Model 302 Data System

August 2018

Starting August 2018 the PeakSimple Model 302 6 channel Chromatography Data System has been re-packaged into a smaller box.

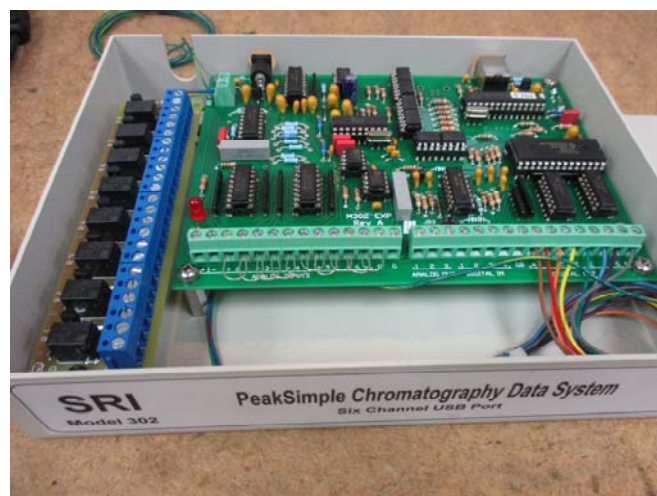
The new box comes with a 2 meter USB cable and power supply which can operate on all worldwide voltages from 100-240 volts AC,

Inside the box is all the same hardware as in the previous much larger box.
